Buffalo Creek Tributaries Mitigation Project

FINAL VERSION

RE: WLS Responses to NCIRT 30-day Review Comments Regarding Task 3 Submittal, Final Mitigation Plan Approval for the Buffalo Creek Tributaries Mitigation Project, USACE AID# SAW-2018-00425, NCDEQ DMS Full-Delivery Project ID #100042, Contract #7422, Neuse River Basin, Cataloging Unit 03020201, Johnston County, NC

Figure 7e – 2019 Aerial Photograph

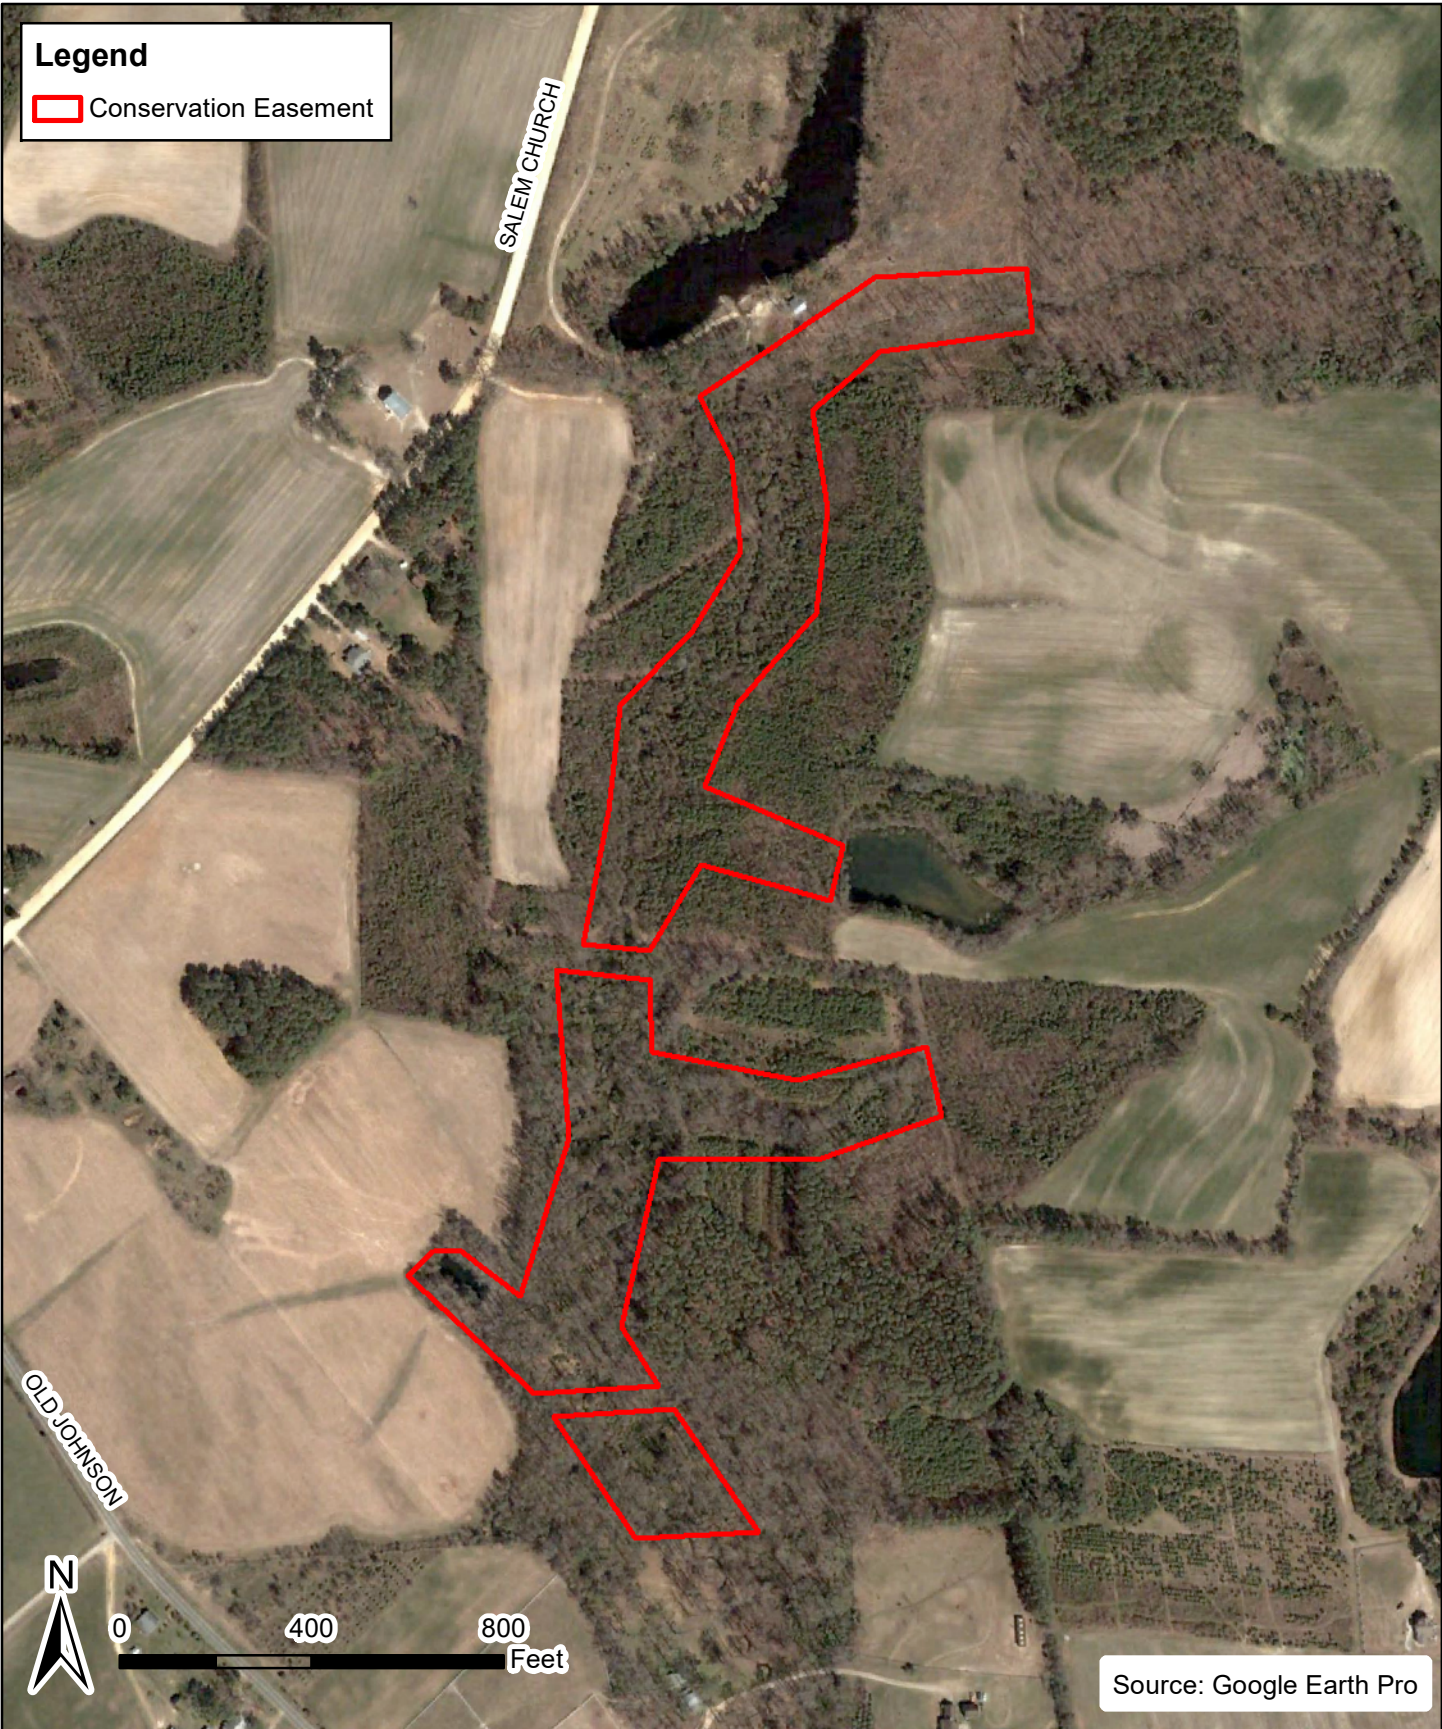
- 1. Section 2- Watershed Approach-this section mentioned an area being developed into a subdivision on stream right near the bottom of MS-R2. One of the Figures (7e) shows a stormwater pond built at the edge of the development, please make sure the designer is aware of where the outlet will drain into the conservation easement and take the necessary design steps to account for the stormflow input.** Response: WLS has coordinated directly with the Cardinal Preserve design engineer and Johnston County Public School Facilities Officer to identify all stormwater devices and stormflow input/outfall locations. Per this correspondence, we have obtained the site grading and stormwater drainage design plans to appropriately size and connect the proposed water quality treatment basins at these outfall locations within the conservation easement. As noted in the comment above, the beginning of R6 is located below existing stormwater BMPs and outlet swales that drain into the project area. The design of upper R6 includes a hardened structure to stabilize both the inlet and outlet of the treatment basin while protecting the proposed stream reach. Section 2, pg2 language has been updated to describe how WLS will account for the stormwater inputs.

SHEET NUMBER
6

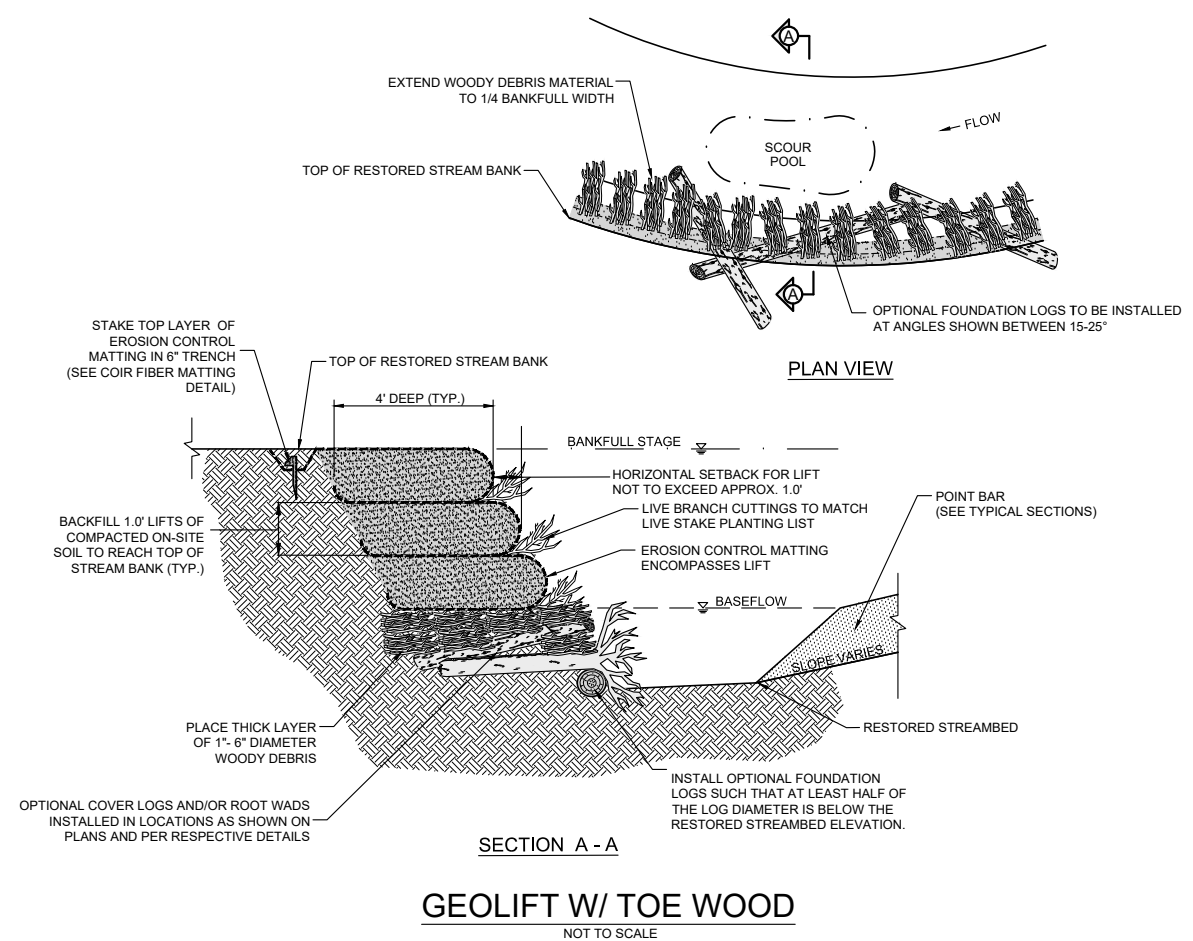
11. Design sheet Typicals- DWR did not find the vernal pool typical. Response: The vernal pool typical is part of the channel block detail shown on sheet 6 of the plan set.

8

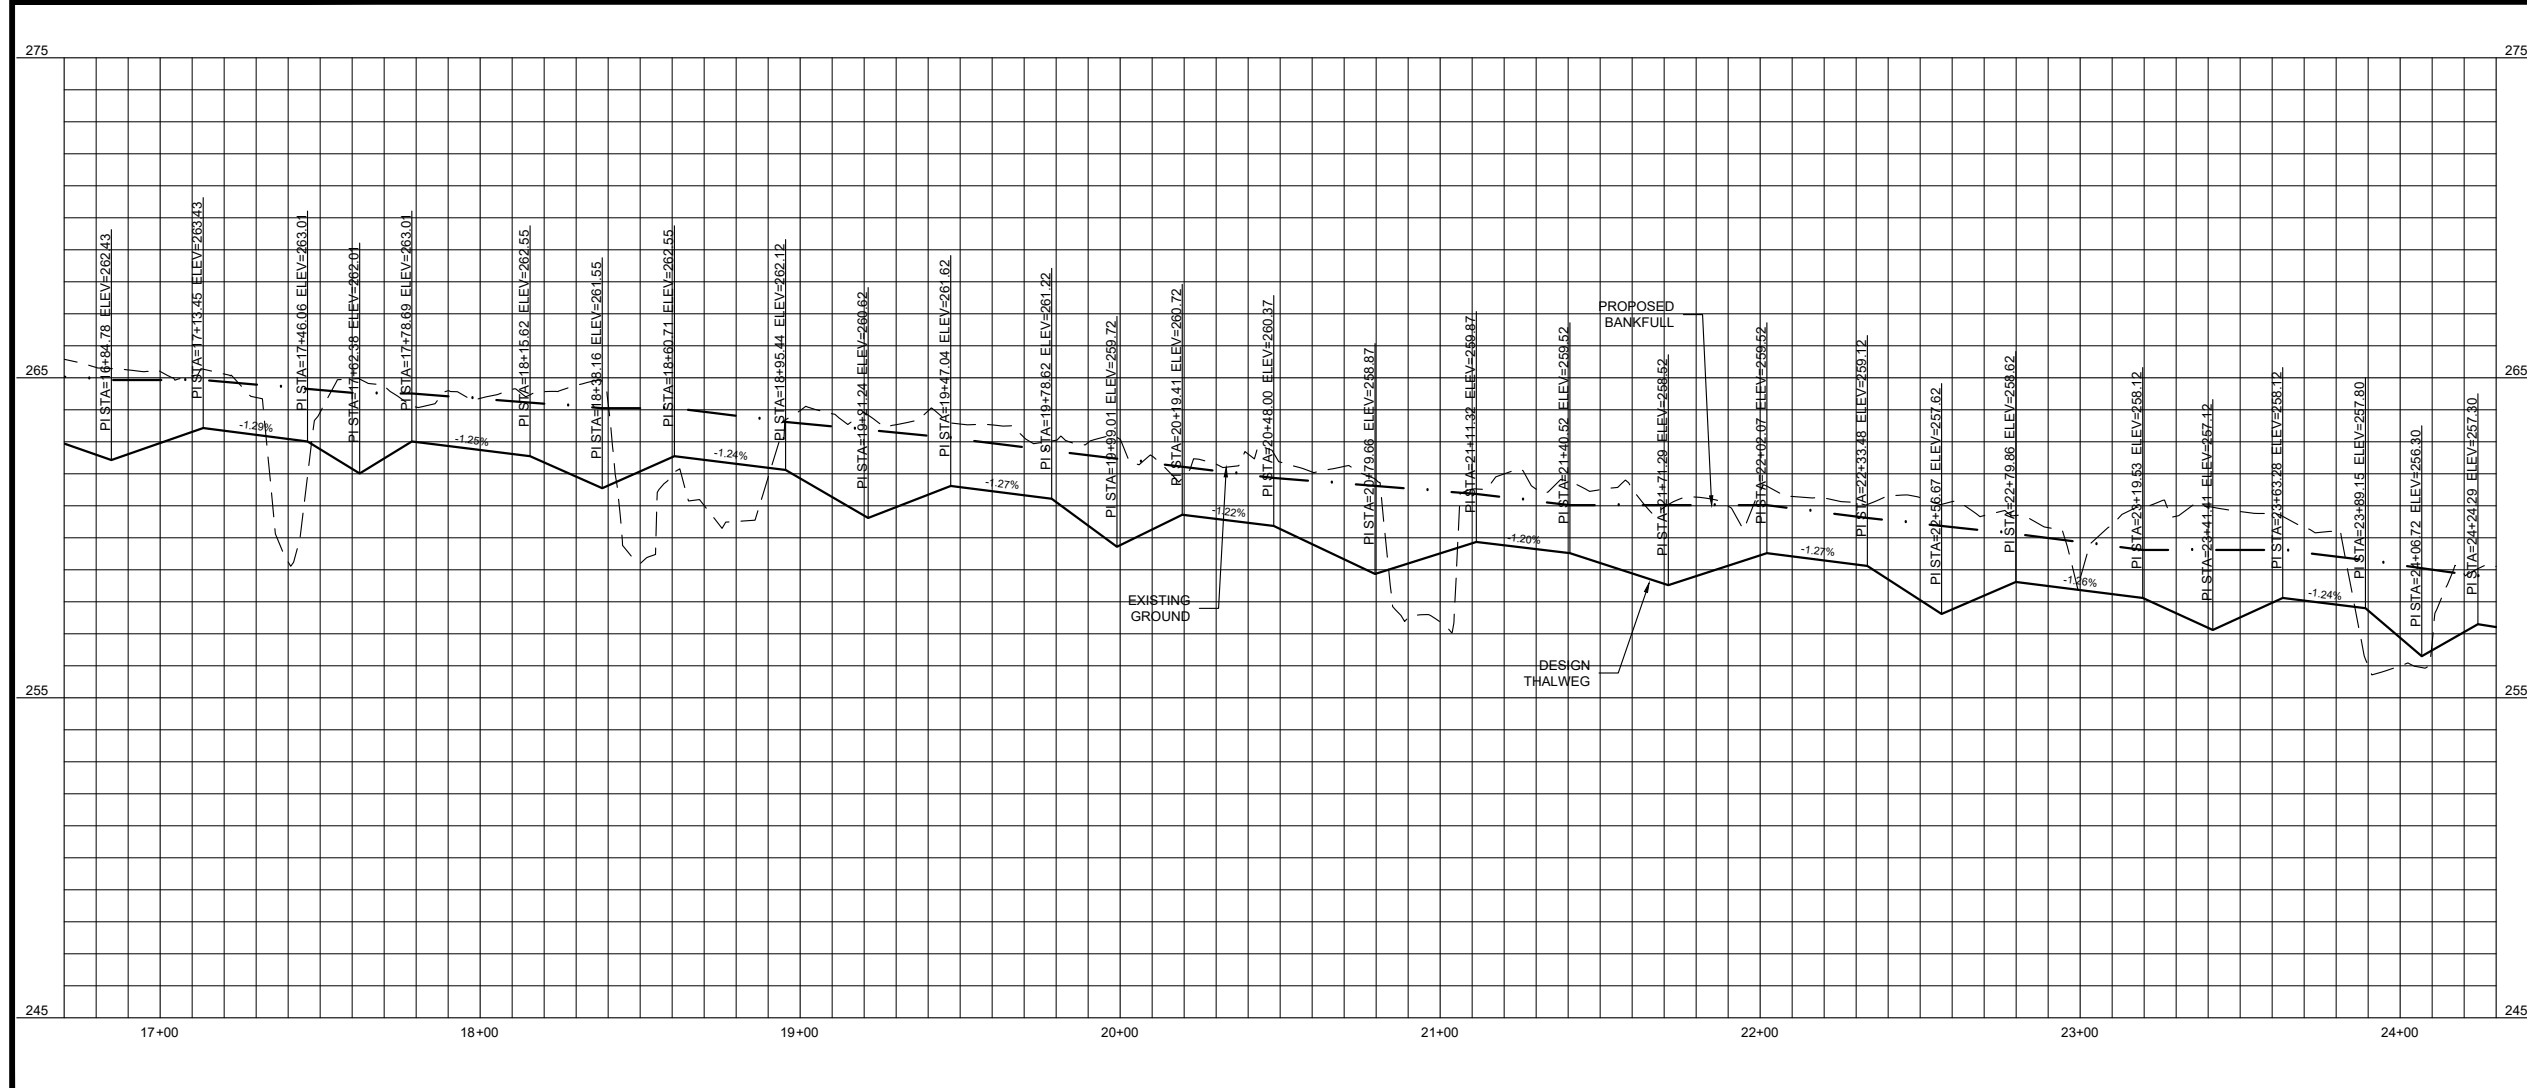
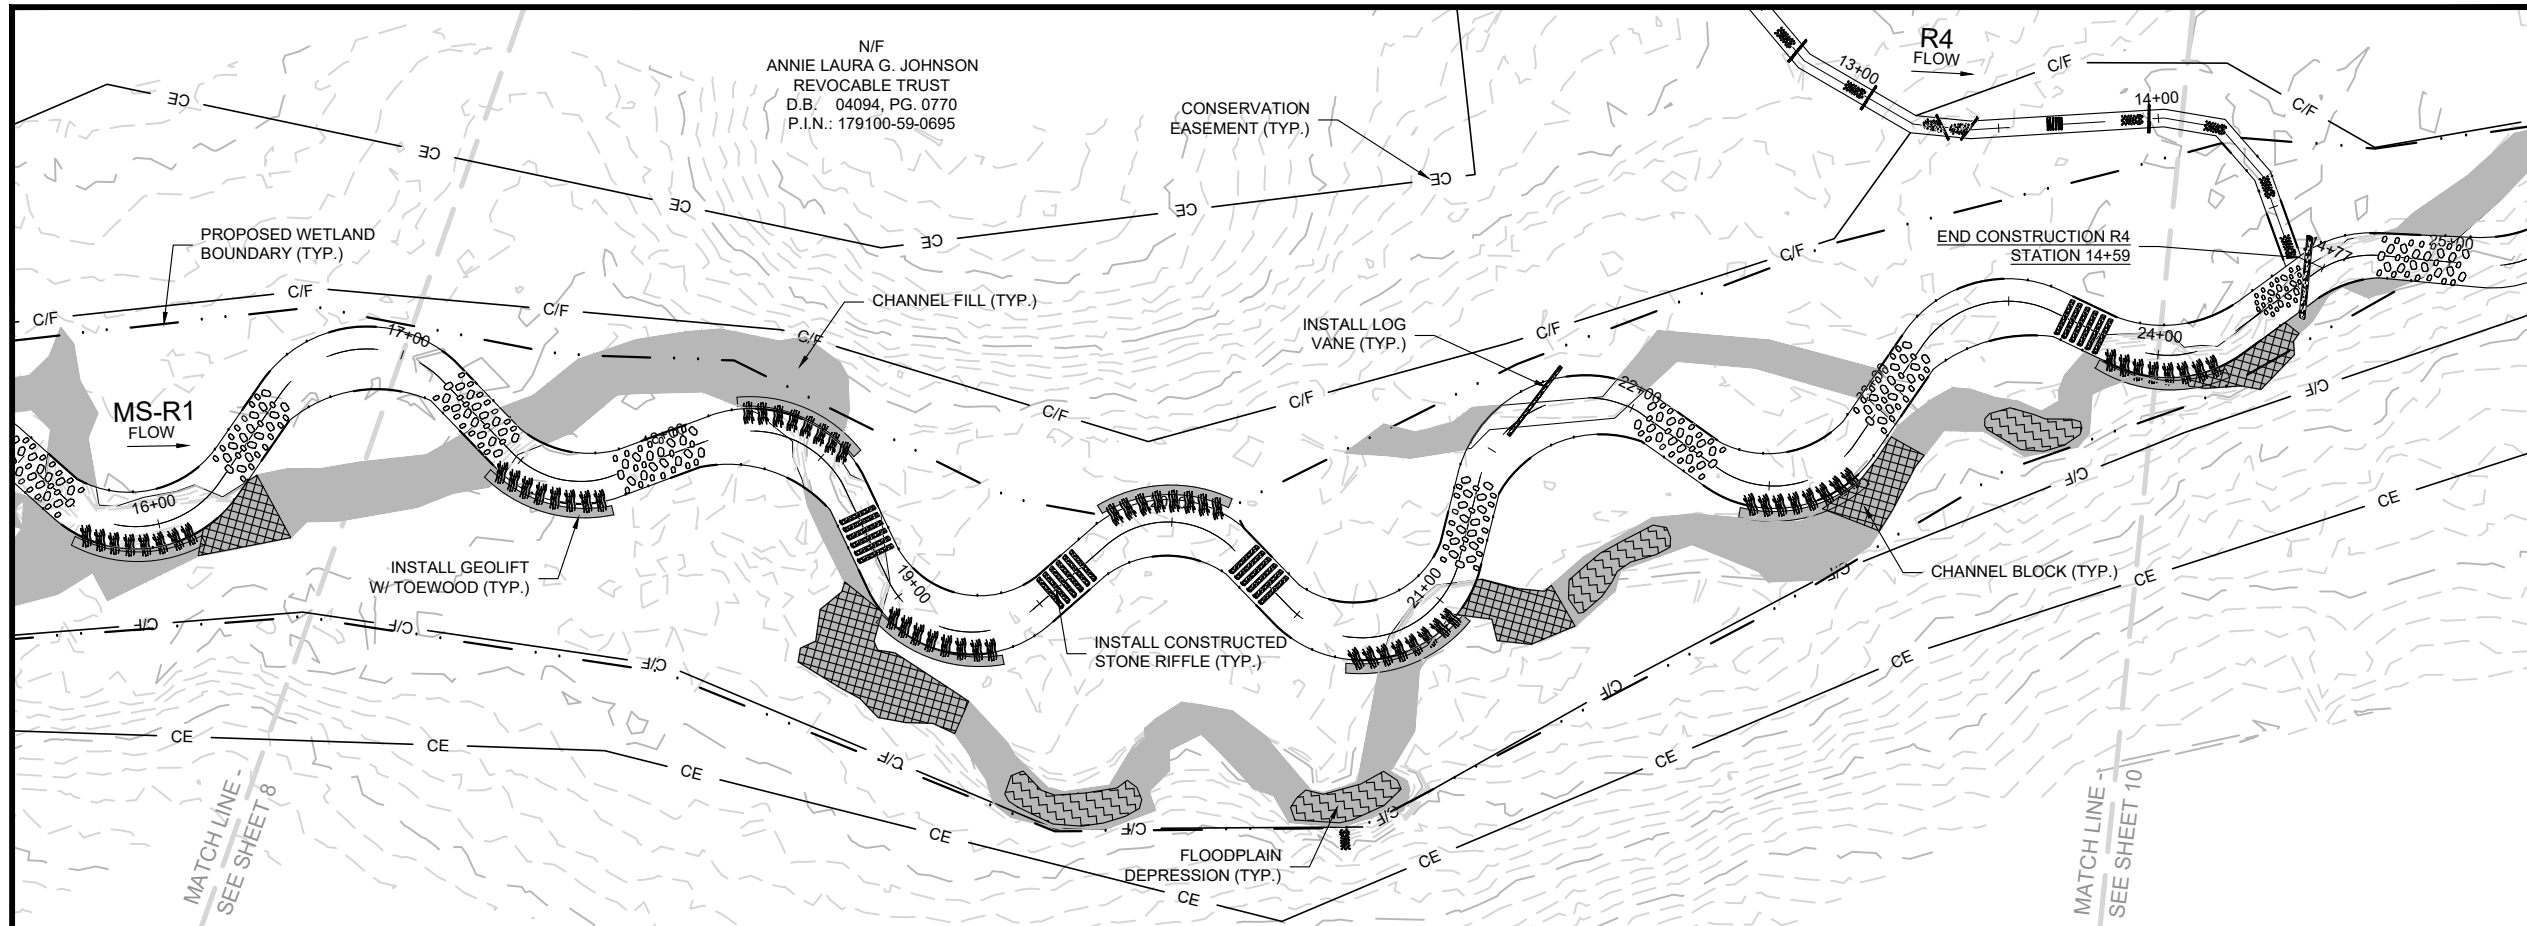
12. Design sheets 8-12- after review of these sheets, it appears that the channel bed is being raised 2-3 feet. Is this correct? DWR is expecting significantly increased overbank flooding to increase the hydrology of the adjacent wetlands. Response: Yes, in many some areas the main channel (MS-R1 and MS-R2) is being raised an average 2-3 feet to accommodate a Priority Level 1 restoration approach. This will likely increase overbank flooding throughout the valley which will increase adjacent wetland hydrology.
